TRI-STATE GENERATION & TRANSMISSION, INC.

FOX RUN SUBSTATION FINAL DRAINAGE REPORT

PCD FILE # PPR-22-044

March 21, 2023

DETENTION BASIN OUTLET STRUCTURE DESIGN

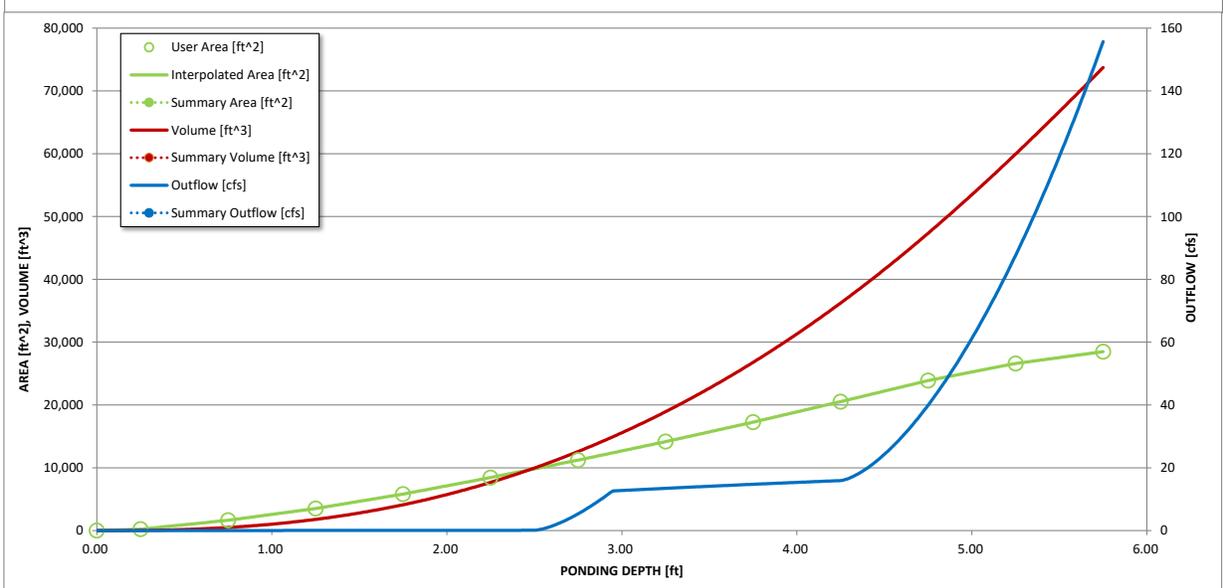
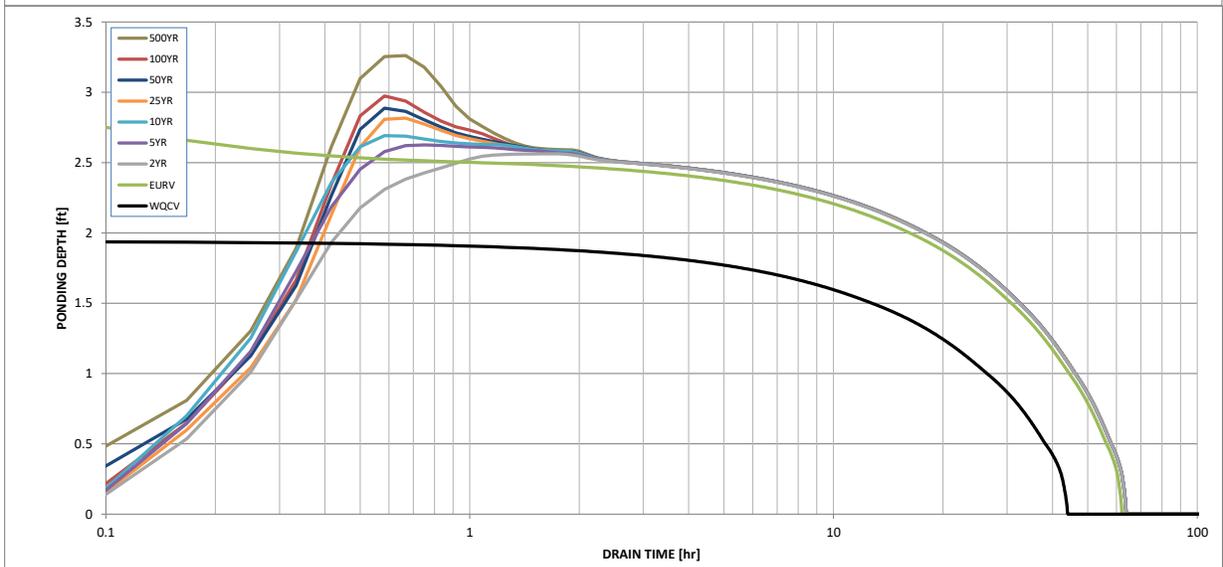
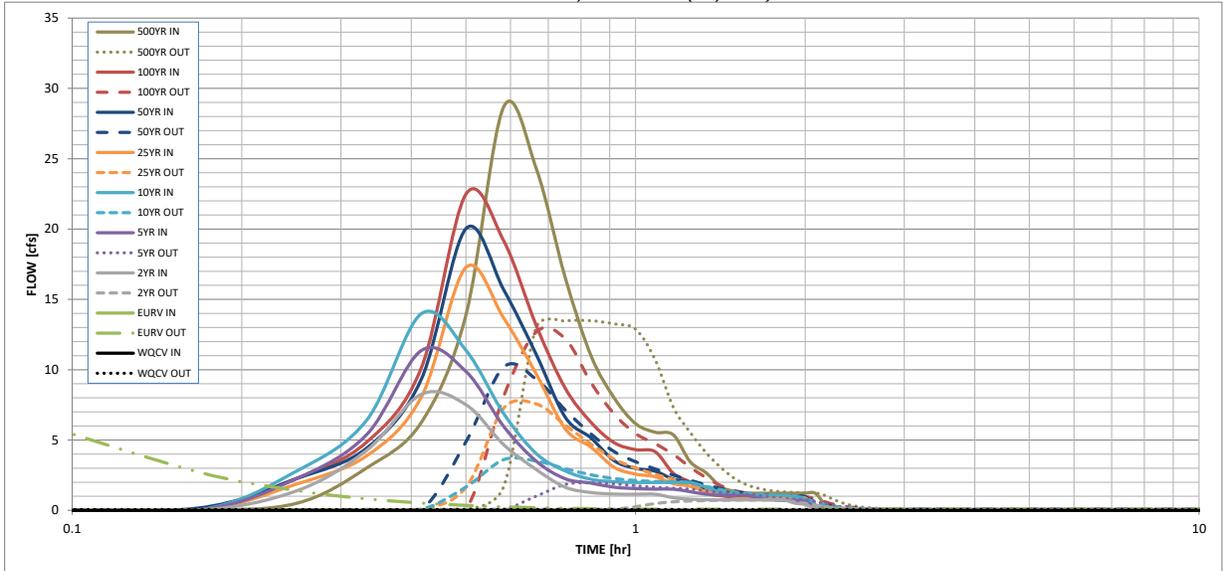
these should be weir/pipe

DMC JOB NO: 21036
SHEET NO: C-1

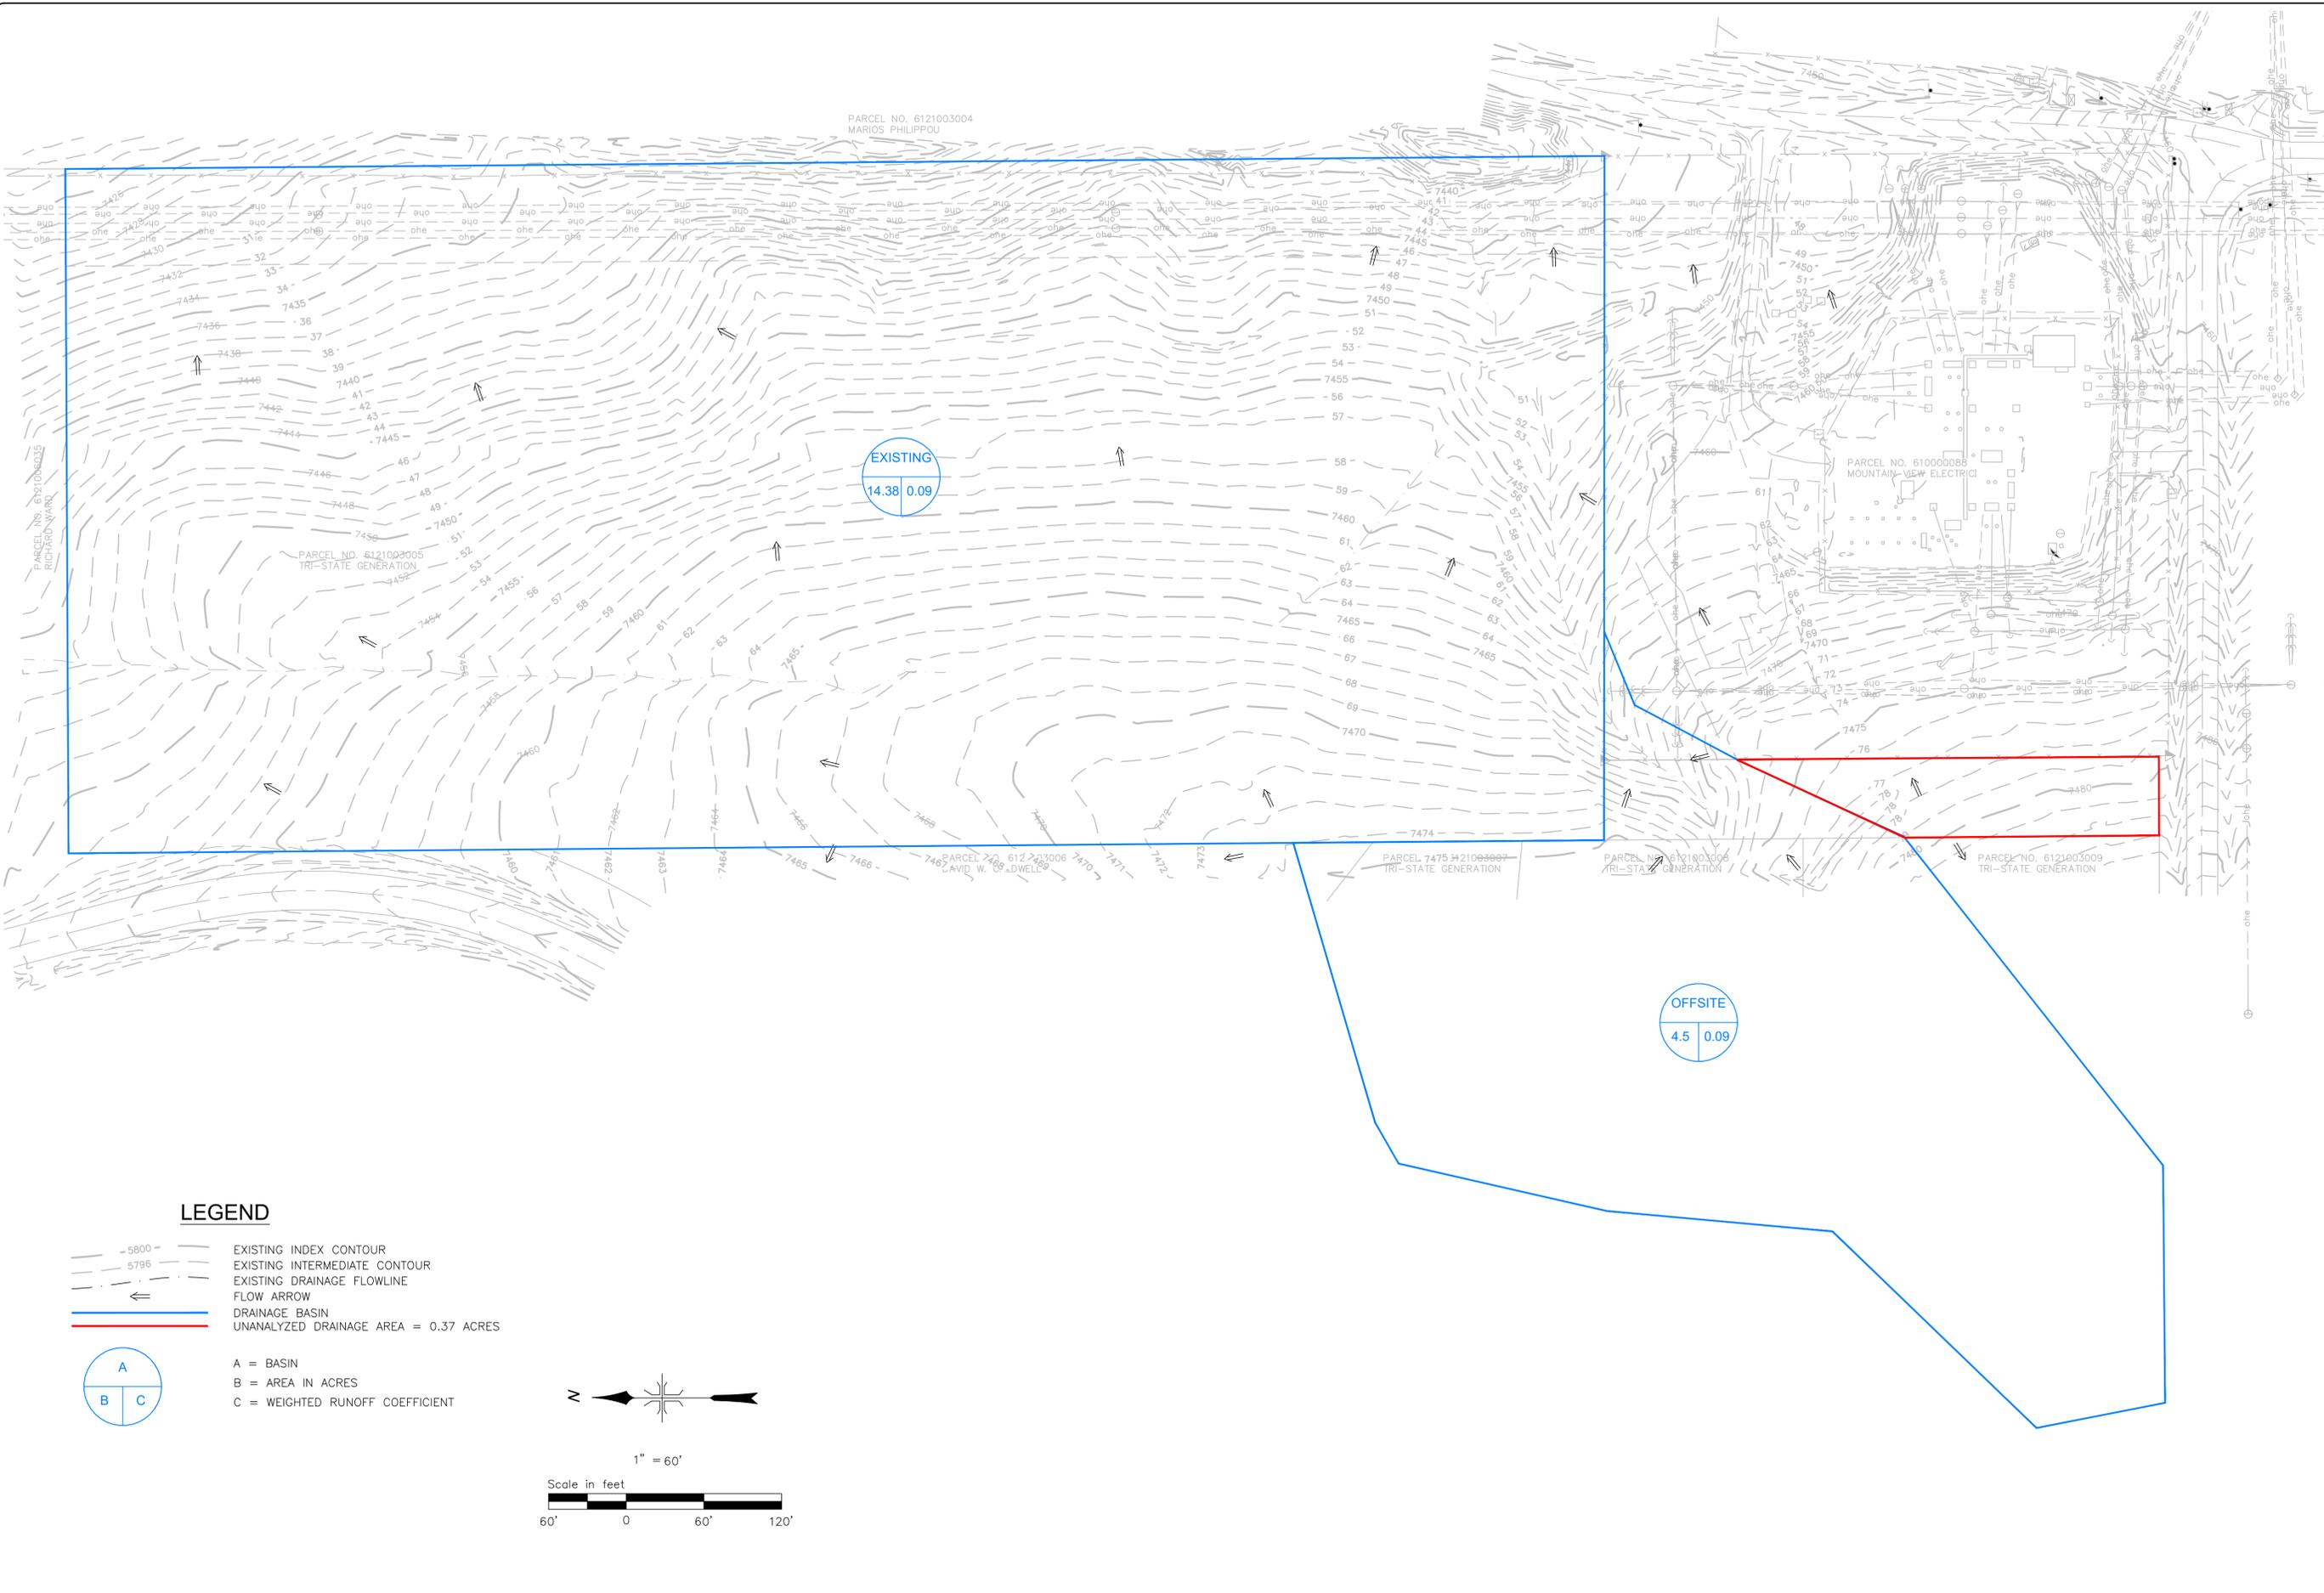
The manner of flow has changed from sheet flow to concentrated flow. Analyze the conveyance path up to the suitable outfall as defined in ECM 3.2.4. The conveyance path must be hydraulically adequate/stable.

Unresolved. Add a paragraph or section in the Drainage Facility design summarizing the results.
 - Identify the velocity along the highlighted section and state whether it's within the permissible non-erosive velocity for the given soil, ground cover, and slope. Mitigation will be required if the concentrated pond discharge is likely to erode the existing ground downstream of the proposed swale. Contact the review engineer to discuss if additional clarification is required.

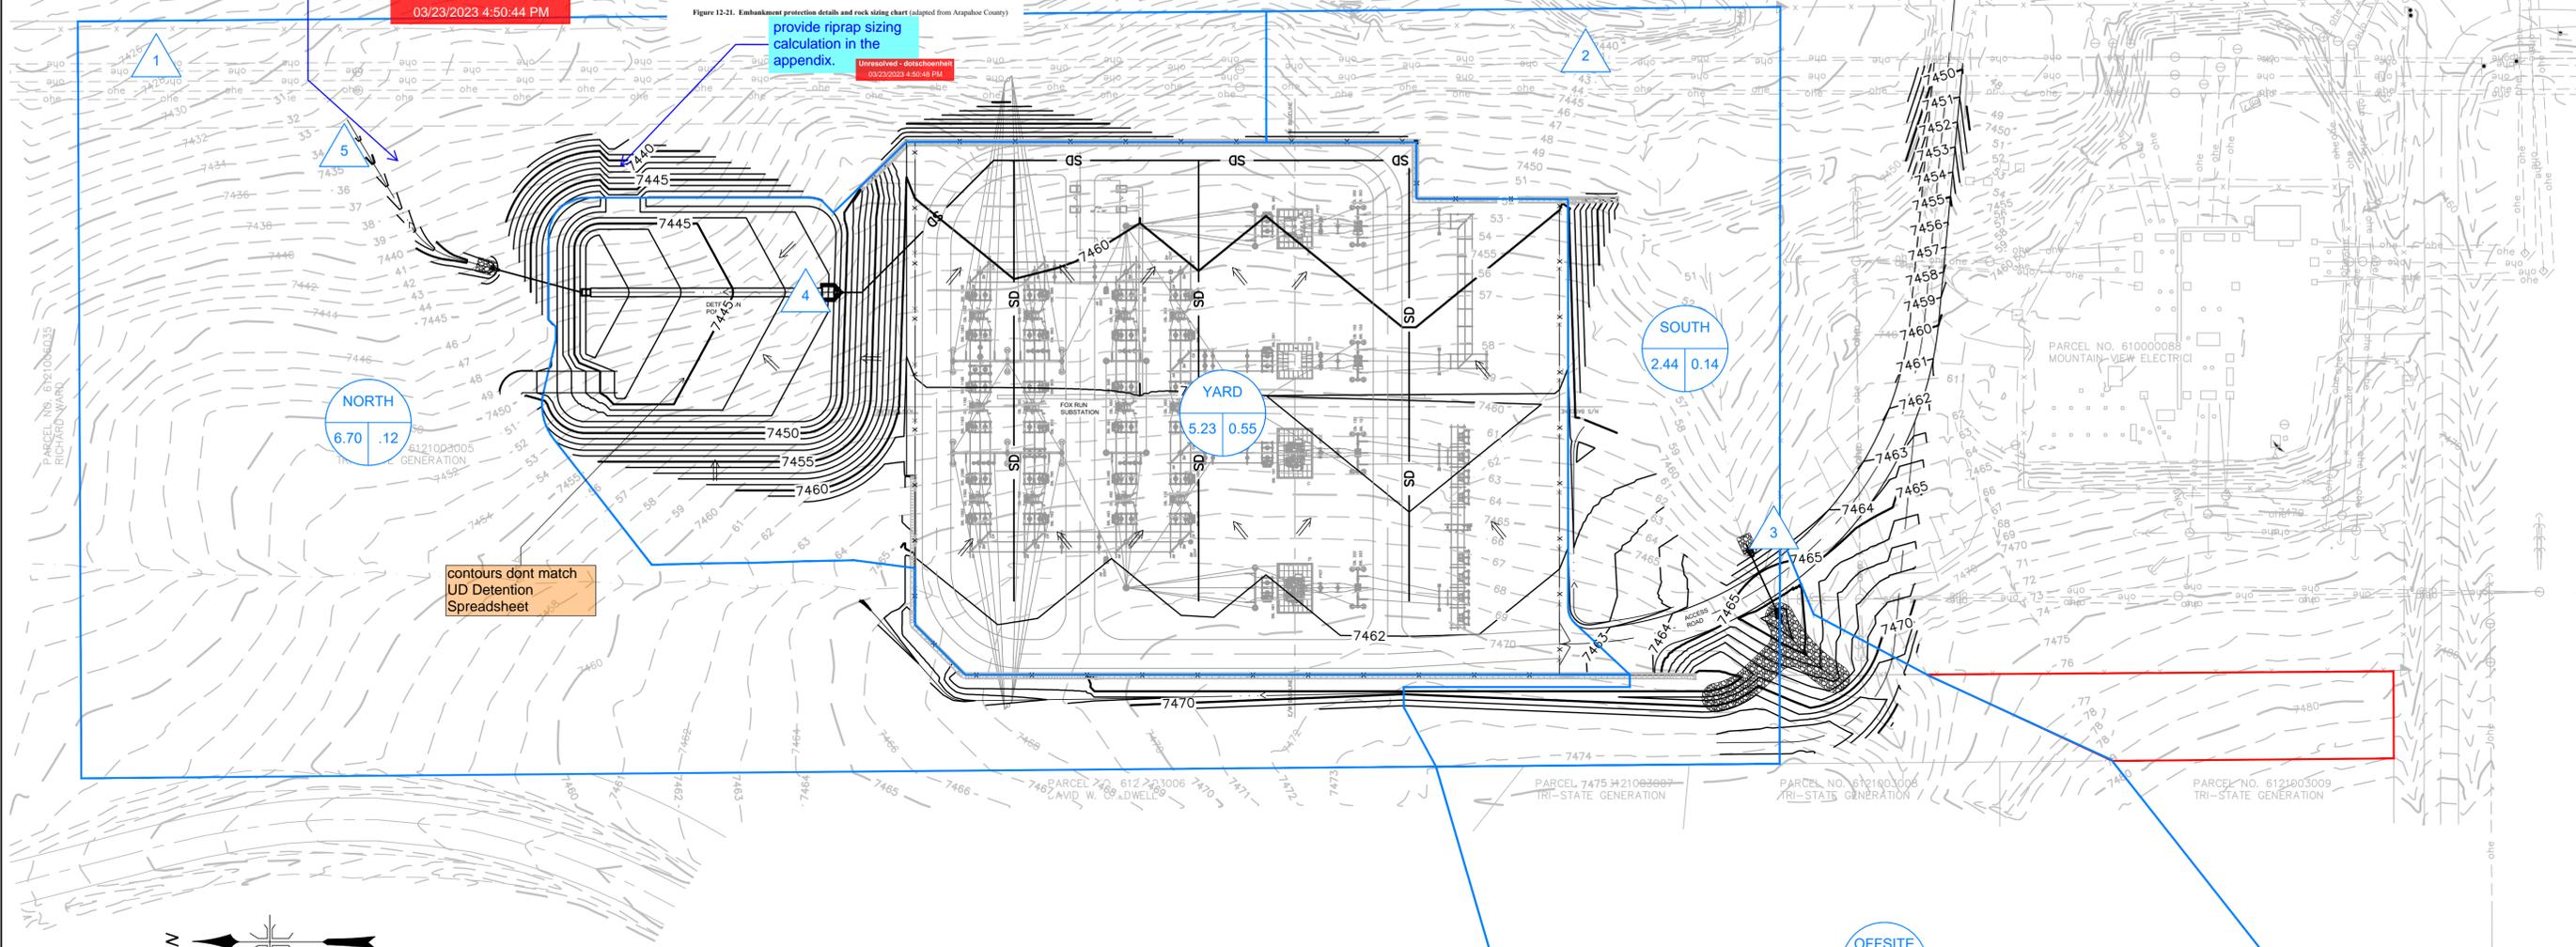
contours dont match UD Detention Spreadsheet
